Access Compliance Report

Public Rights-of-Way

Intersection ID: 23509	Main Street: ALEXANDER_RD	Cross Street: SUMMER_DARBY_LN	Location: NE
ADA ID: 21D98BF60C1B	Ramp Type: PerpDiag	Initial Pass/Fail: Fail	Overall Compliance: No
Severity Score: 72.5			
Codes/Mitigation Info/Possible Solution		Field Measurements/Component Compliance

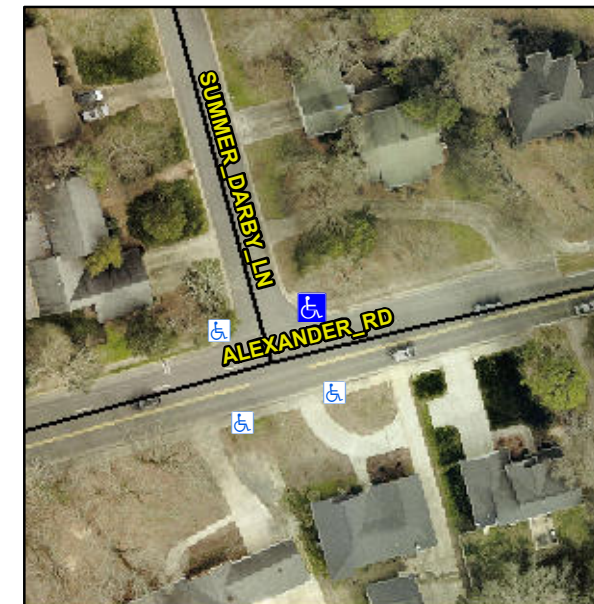
Compliance	Description	Data	Compliance	Description	Data
N/A	Ramp Length (in)	48.0	No	Ramp Slope (%)	16.3
No	Ramp Width (in)	28.0	No	Ramp XSlope (%)	6.8
N/A	Flare Type LT	N/A	N/A	Flare Type RT	N/A
N/A	Flare Slope LT (%)	N/A	N/A	Flare Slope RT (%)	N/A
N/A	Flare Traversable LT?	N/A	N/A	Flare Traversable RT?	N/A
N/A	Landing Length (in)	N/A	N/A	DWS Provided?	N/A
N/A	Landing Width (in)	N/A	N/A	DWS Contrast?	N/A
N/A	Landing Slope (%)	N/A	N/A	DWS Length (in)	N/A
N/A	Landing X Slope (%)	N/A	N/A	DWS Full Width?	N/A
N/A	Landing Curb? (Y/N)	N/A	N/A	DWS Offset (in)	N/A
N/A	Shared Landing?	N/A			
N/A	Gutter Ponding?	N/A	N/A	Gutter Slope (%)	N/A
N/A	Gutter Lip Ht (in)	N/A	N/A	Gutter X Slope (%)	N/A
N/A	Painted X Walk1?	No	N/A	Painted X Walk2?	No
	X Walk 1 Direction	To W		X Walk 2 Direction	To S
N/A	X Walk 1 Width (in)	N/A	N/A	X Walk 2 Width (in)	N/A
	X Walk 1 Slope (%)	0.7		X Walk 2 Slope (%)	7.8
	X Walk 1 X Slope (%)	3.0		X Walk 2 X Slope (%)	2.6

Remove & Replace Curb Ramp With Two New Directional Ramps or Equivalent.
